UNITED STATES PATENT AND TRADEMARK OFFICE

APPLICATION NO.	FILING DATE	FIRST NAMED INVENTOR	ATTORNEY DOCKET NO.	CONFIRMATION NO.
10/707,407	12/11/2003	Abdelaziz Ikhlef	GEMS8081.201	1406
27061	7590	05/26/2006	EXAMINER	
ZIOLKOWSKI PATENT SOLUTIONS GROUP, SC (GEMS)			KAO, CHIH CHENG G	
14135 NORTH CEDARBURG ROAD			ART UNIT	
MEQUON, WI 53097			PAPER NUMBER	
			2882

Office Action Summary	Application No. 10/707,407	Applicant(s) IKHLEF ET AL.	
	Examiner Chih-Cheng Glen Kao	Art Unit 2882

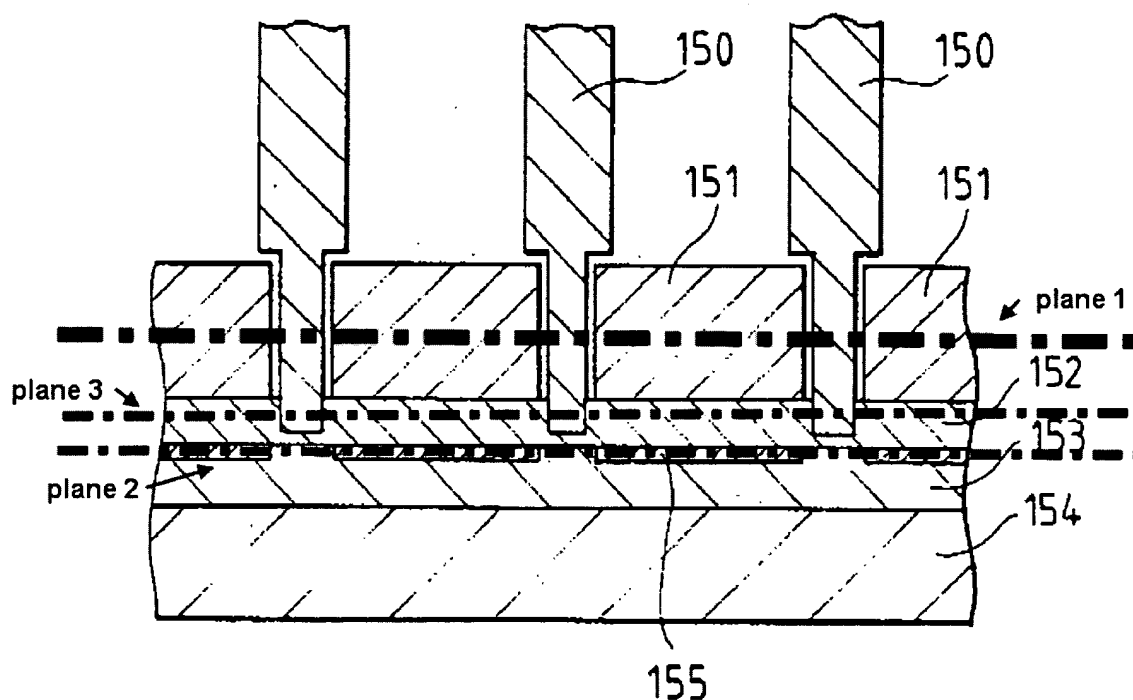
29. Regarding at least claim 1, applicant argues that Fujii et al. fails to teach or suggest an optical mask arranged along a third plane parallel to the first and the second planes, and disposed between the scintillator array and the photodiode array. The examiner disagrees. Fujii et al. does teach or suggest an optical mask arranged along a third plane (fig. 9, #150) parallel to the first and the second planes, and disposed between the scintillator array (fig. 9, #151) and the photodiode array (fig. 9, #153). This is further illustrated in figure 9 modified below.
